UNITED STATES PATENT AND TRADEMARK OFFICE

10/728,833

DETAILED ACTION

US 6,404,312 B1

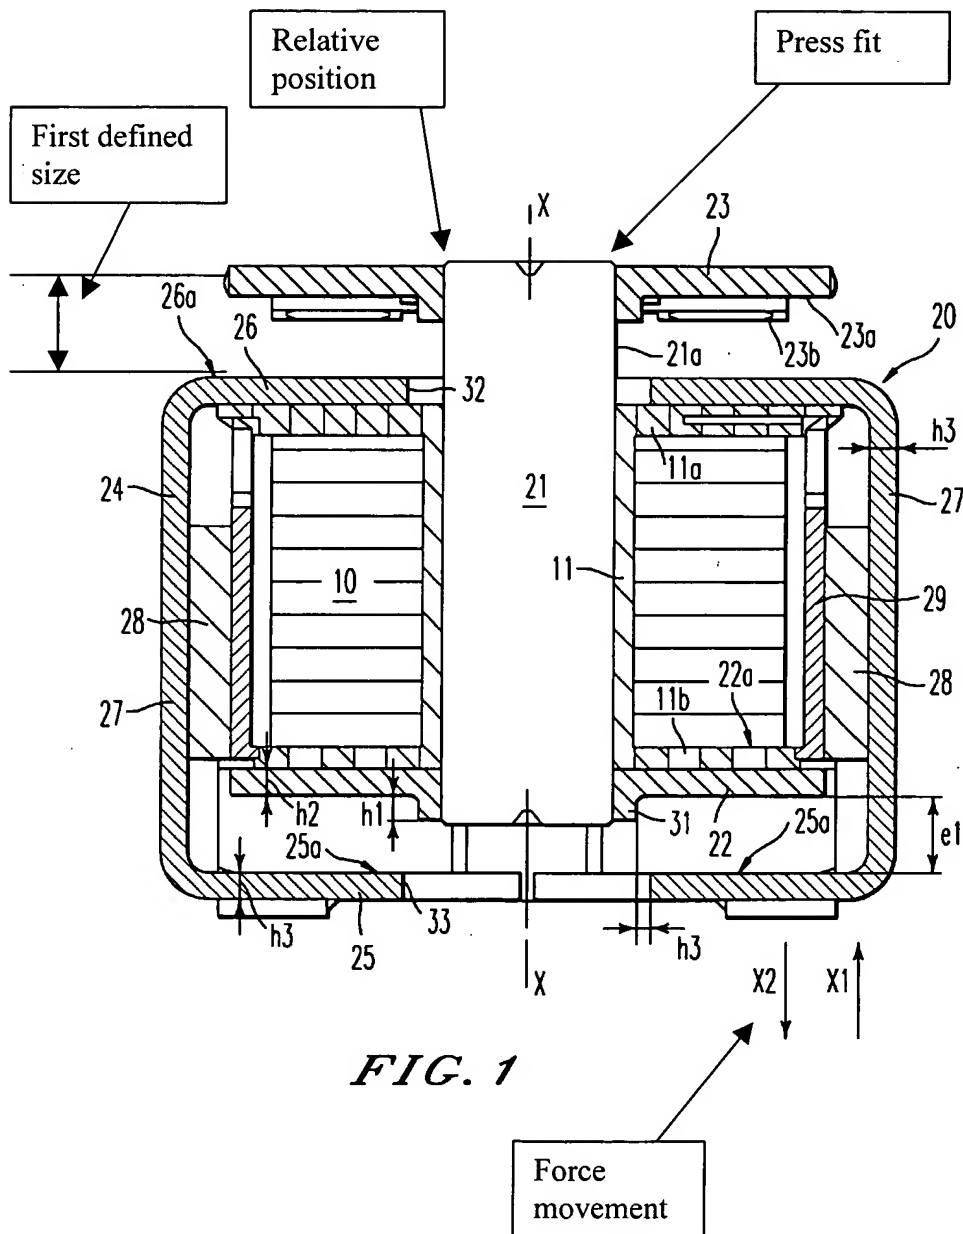
Comtois et al. teach a process of adjusting a spacing within a magnetic circuit comprising steps of: adjusting a relative position between an armature plate (23) and an armature bolt (21) by a pressing operation, to a first defined size, which is defined between the plate and the circuit, after the armature plate and the armature bolt are assembled to form the magnet armature as shown in Fig. 1, wherein the pressing force is applied to the preassembled magnet armature assembly until the first defined size is reached such as contact the plate to a surface of the circuit (26a) (see also col. 2, line 5 to col. 3, line 11). The armature plate (23) is fixed to the armature bolt (21) prior to adjust the relative position and the relative position is established by fixing the armature plate (23) to the armature bolt (21). Therefore, a press fit of the armature plate to the armature bolt is varied in terms of the relative position of the armature plate to the armature bolt as shown in Fig. 1.
